# CCA Modes in 802.15.4

**This submission provides a background on 802.15.4ab NB modes, reviews the CCA Modes in 802.15.4me Draft 3, and provides a way forward to improve coexistence between 802.11 and 802.15.4ab NB.**

# Background: NBA-MMS (10.38) with optional LBT

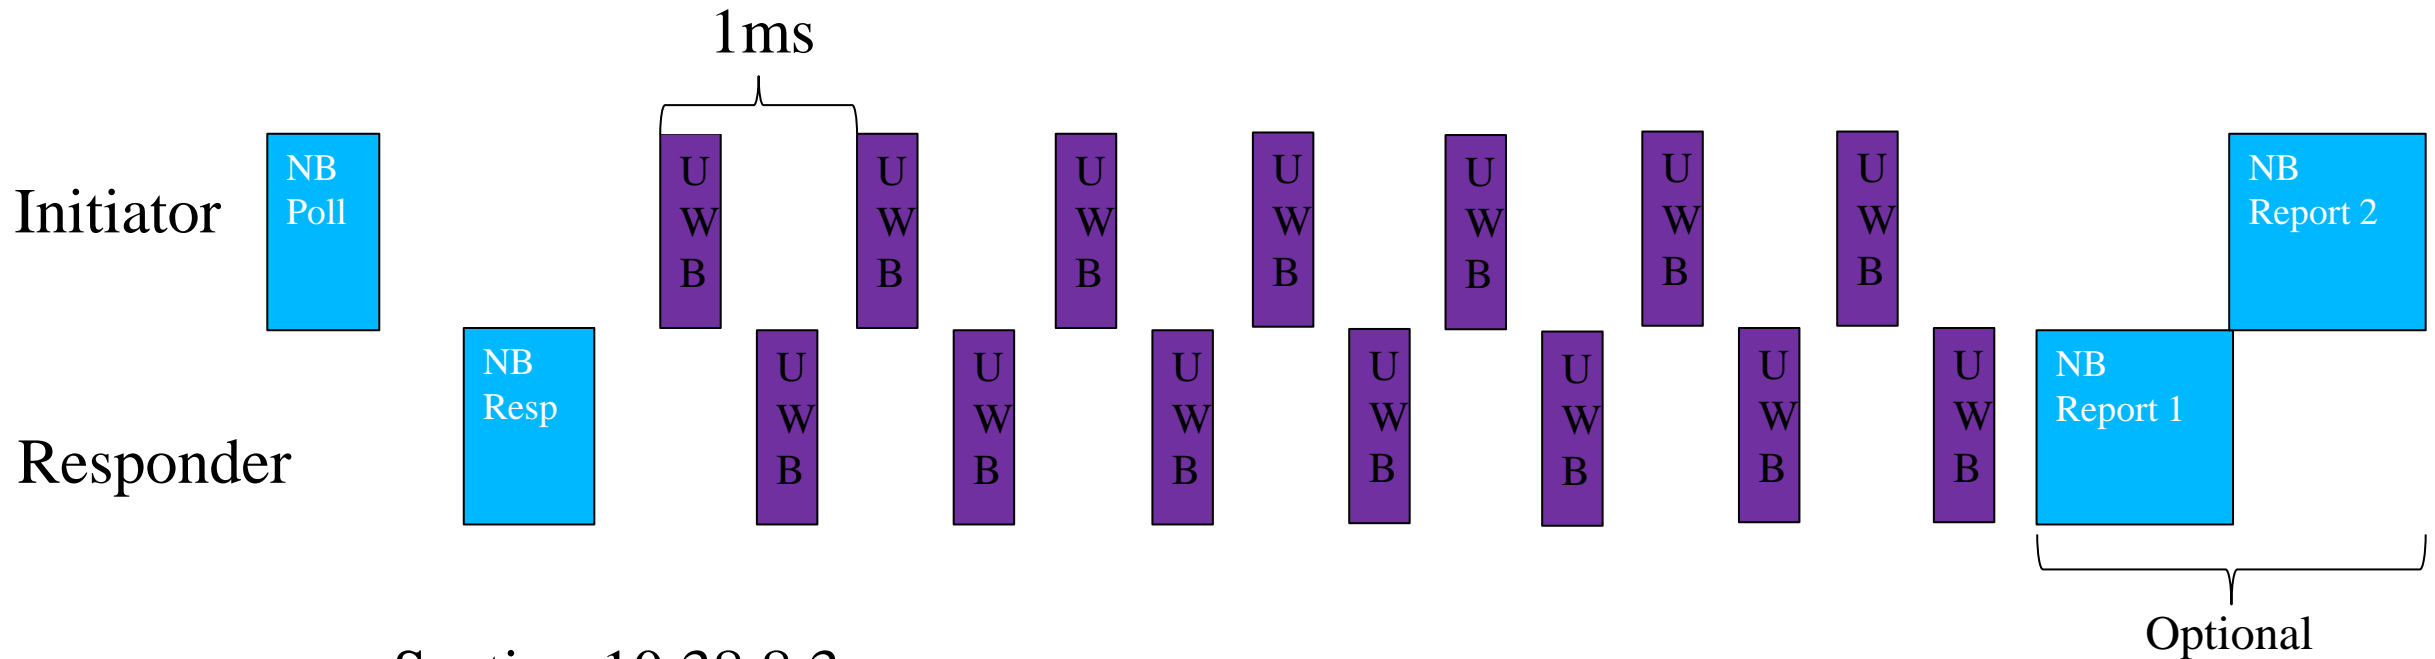
LBT shall be applied to channel numbers 50 to 249 according to regulatory constraints. LBT may be applied to all channels in the absence of regulatory constraints, for example, to improve coexistence with other spectrum users. The LBT protocol shall be applied by initiator and responder independently in each transmission slot, even if the same channel is used consecutively.

Benjamin Rolfe	161		Blind Creek Associates	Technical	57	10.38.8.3	13		<p>The behavior defined in this clause already exists in the standard. Use one of the existing channel access methods, defining the control parameters to use to achieve the desired behavior. Unslotted CSMA or SSBD are the optimal choices. For example using SSBD we set</p>	<p>Replace clause text:  Channel access using listen before talk may be required by regulatory domains, and/or may be desired for improved coexistence performance. When used for narrow band assist SSBD as defined in 6.2.2.2 is recommended using the following control attribute values:  phyCcaDuration should be set to less than 16 microseconds or as required by local regulations;  macSsbdUnitBackoffPeriod should be set to 1 (microsecond);  macSsbdMinBf and macSsbdMaxBf should be set to 1;  macSsbdMaxBackoffs should be set to 1;  macSsbdTxOnEnd should be set to FALSE;  phyCcaMode should be set to 1 (energy above threshold)  Note: use of these settings assures the channel access attempt will complete within 16 microseconds.  With these attribute values, channel access will return Success when CCA indicates clear, and Failure when energy above the detection threshold is detected. When channel access returns Failure, the radio shall defer transmission for the current ranging block.  Figure 35 illustrates this channel access for the two-sided packet exchange across two consecutive ranging slots between the initiator and responder, as needed during the UWB MMS control phase. The timings shown in Figure 35 are based on information in [B3].  LBT shall used when required by regulatory constraints. LBT may be used to all channels in the absence of regulatory constraints, for example, to improve coexistence with other spectrum users. When used, LBT shall be performed by initiator and responder independently in each transmission slot, even if the same channel is used consecutively.  And update the figure as needed</p>

**For both NB-Data and NBA-MMS described 802.15.4ab Sections 10.43 and 10.38, CCA mode 1, is the mandatory channel access mechanism with the following parameters:**

1. ED threshold of -80 dBm/MHz
  2. phyCCADuration value between 16-25 us
  3. probability of detection  $\geq 90\%$
- **Alternatively, if SSBD is the preferred channel access mechanism, in addition to the 3 parameters above, these additional SSBD parameters shall be used**
    - macSsbdMaxBackoffs = 0
    - macSsbdPersistence = 0
    - macSsbdTxOnEnd = False
    - macSsbdUnitBackoffPeriod = 1 (microsecond)
    - macSsbdMinBf and macSsbdMaxBf = 1
